Observation Schematic Vs Layout changes.

• **Design Source:** Reference Design **DI board_tidc249b** Download from TI Website.

Observation 1)

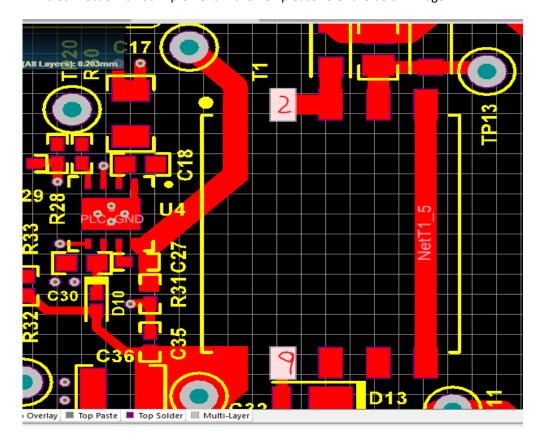
In the Reference design Schematic sheet 1: T1 (Path no : 750342178) Pin no 2 and 9th pins are connected each other as shown in the below image.

This Connection is not implement in the PCB please refer the below image

Observation 2)

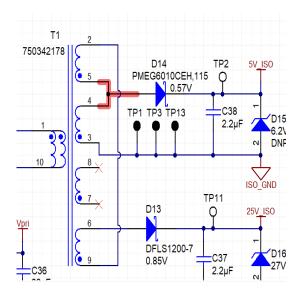
T1 Pin 5 and 4 are short and its connected to D14 and this not implemented in the PCB.

Observation 3)

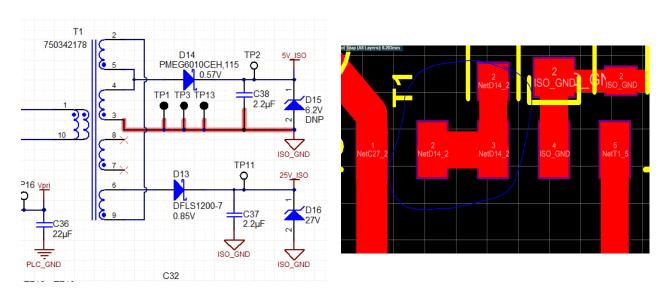
In the Schematic T1 part Pin no 3 is connected to the ISO GND but in the PCB its not connected.
